CITY OF ALBUQUERQUE

Site: Valle De Atrisco Apartments

Re: Drainage Ordinance (14-5-2-1) Violations for Erosion and Sediment Control and Construction Site Waste(s)

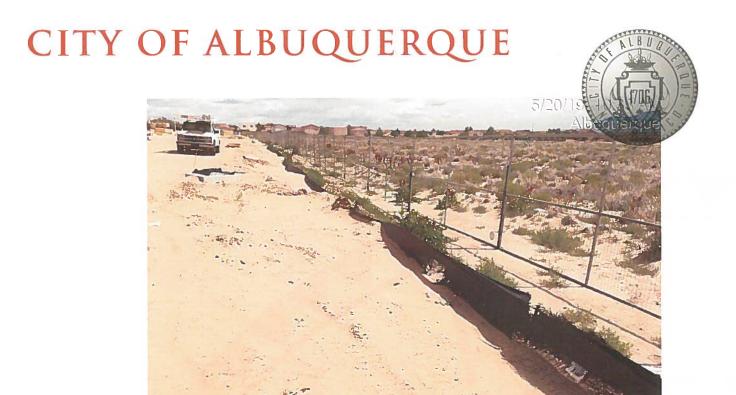
Silt fence requires maintenance and construction and domestic waste not in an acceptable container.

2 Remove sediment from the silt fence so it is less than 50% the height of the silt fence.

3. Repair/replace the silt fence where necessary.

5. Place and keep construction and domestic waste(s) in an acceptable container.

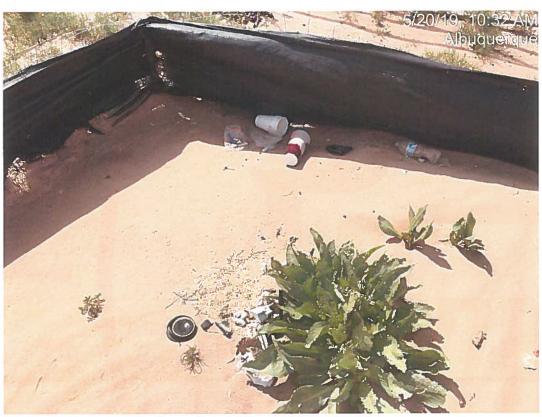
Silt fence is full.

Silt fence is torn.
